Pre-Inspection Mezzanine Walkthrough Checklist

Date: 01/15/2015		Station Name: Courthouse - K01		Mezzanine #: 096		Completed By: Tino Sahoo	
Check	Task	Equipment	Room ID	Notes			
<input checked="" type="checkbox"/>	Verify that electrical power design matches the field/record. Identify locations of the electrical equipment.	Electrical Source Panel Name/Number: SWBD Essential Source Breaker Name/Number: "Transformer T4 (For Panel EF)" Electrical AFC Panel Name/Number: EF	Rm 305 Rm 305 Rm 205	Room 305 is AC SWBD battery room.			
<input checked="" type="checkbox"/>	Verify if disconnect switch is connected to the AFC electrical power panel. Low or High voltage SMNT/POWR escorts requirements?	Disconnect Name/Number: SMNT/POWR escorts: HIGH Voltage					
<input checked="" type="checkbox"/>	Check if there is a shared raceway between AFC Panel and Kiosk and identify additional source panels to be de-energized.	Do AFC Panel loads feed into a shared raceway e.g. trench or trough? If Yes, specify source panels in notes. NO

NEW ELECTRONIC PAY PROGRAM (NEPP)
 IN METRO RAIL STATIONS
 COURT HOUSE
 PANEL SCHEDULE

AS BUILT
AS BUILT AS OF 8-1-79 22007A
**WASHINGTON METROPOLITAN
AREA TRANSIT AUTHORITY**

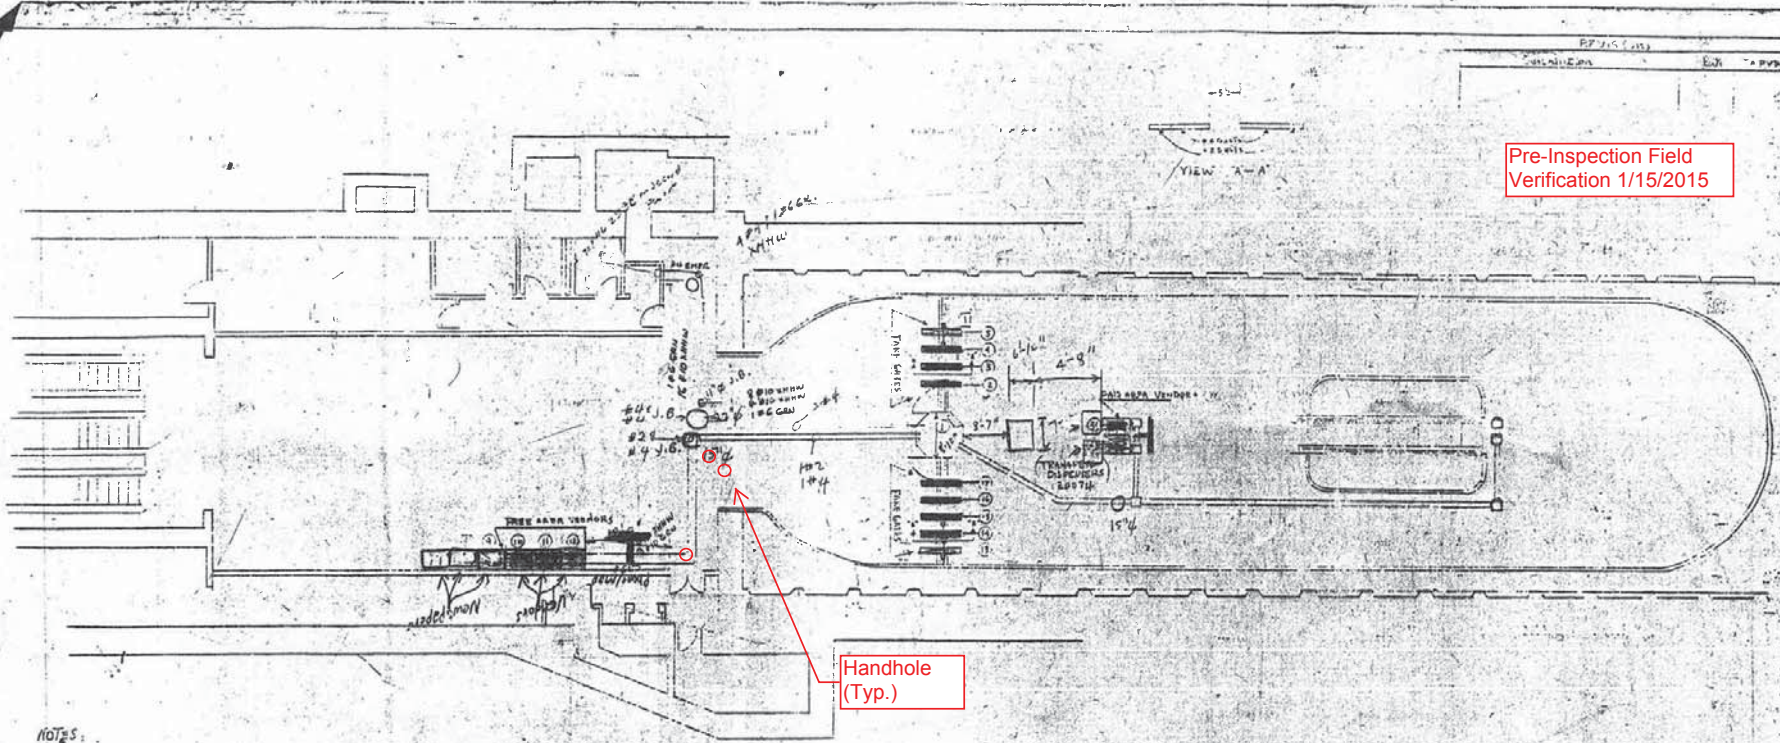
Fare gate
 #11 19 ~~20~~ 20 - 21
 #12 19 18 - 19
 #13 18 Smart
 #14 11 Smart
 #15 11 Smart
 #16 10

add fare
 #17 36 51
 #18 29 50

#31 } TRANSFER DISP. HAVE BEEN
 #33 } TERMINATED AS OF 06-15-09 PERMANENTLY
 #23 NEW AFC UNDER #34

Pre-Inspection Field
Verification 1/15/2015

CONTRACT NUMBER: 926-A
 DRAWING NUMBER: 926-0461
 SHEET 1 OF 1
 TITLE: EAST FALLS CHURCH STATION INSTALLATION PLAN
 CODE IDENT NO: 57560
 DRAWN: F. STREUB
 CHECKED: J. STREUB
 REVISIONS: NONE
 DATE: 1/11/15

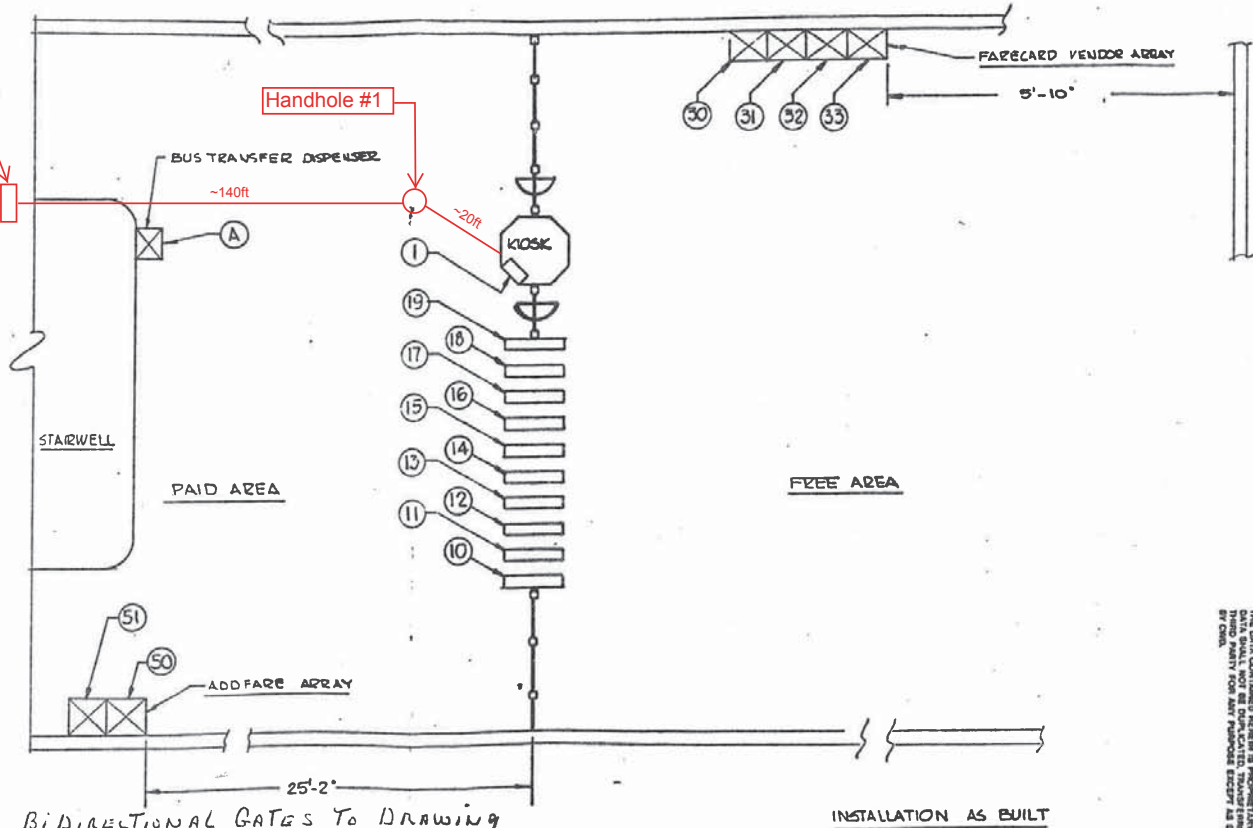
M WASHINGTON METROPOLITAN AREA TRANSIT AUTHORITY
 APPROVED AND CORRECTED
 (RESUBMITTAL NOT REQUIRED)
 Approval Does Not Relieve the Contractor of the Responsibility for the Accuracy of this Document or for Full Compliance with the Contract Requirements.
 BY: *[Signature]*
 For Contracting Officer
 DATE: 1-11-15

1. ADD BIDIRECTIONAL GATES TO DRAWING
2. SERVICE GATE NO. 12 BREAKER NO. 1
3. " " " 13 " " 2
4. " " " 14 " " 3
5. " " " 15 " " 4
6. " " " 16 " " 5
7. " " " 17 " " 6
8. " " " 18 " " 7
9. " " " 19 " " 8
10. " " " 20 " " 9

CONTRACT NUMBER: 926-0458
DRAWING NUMBER: 926-0458
SHEET OF: 17
TITLE: DUNN LORING STATION INSTALLATION PLAN
CODE IDENT NO: 57560
DATE: 11/20/2014

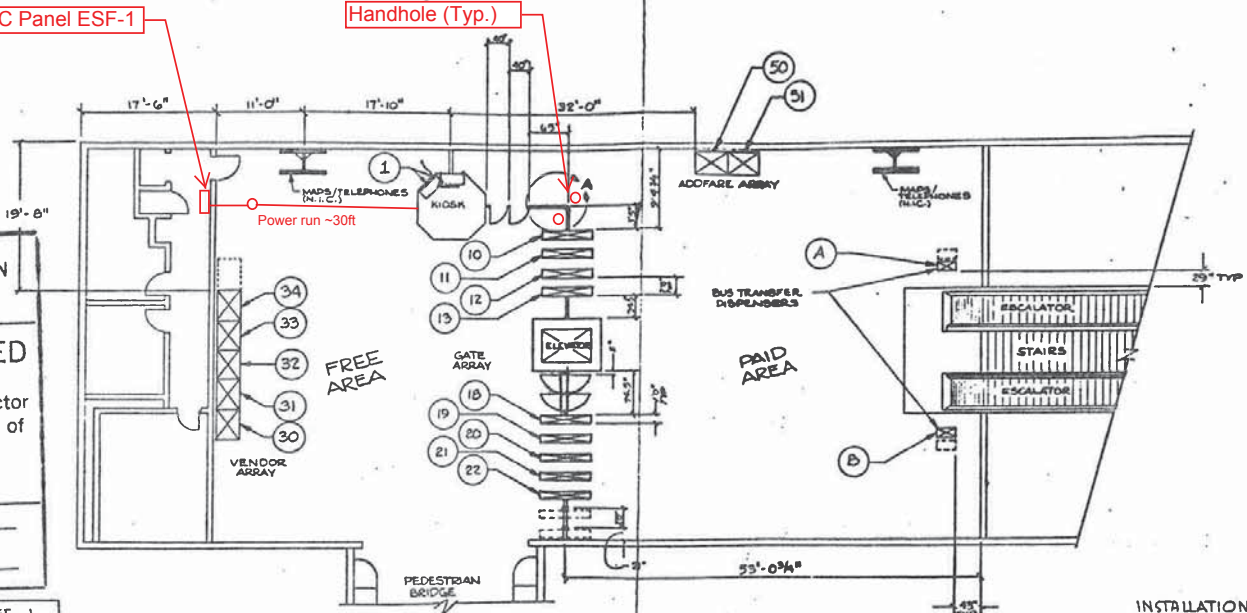
1. DELETE SERVICE GATES BY ELEVATOR
2. RE-LOCATE EDADS IN KIOSK
3. FARE GATE No. 22 ON CIRCUIT BREAKER No. 2
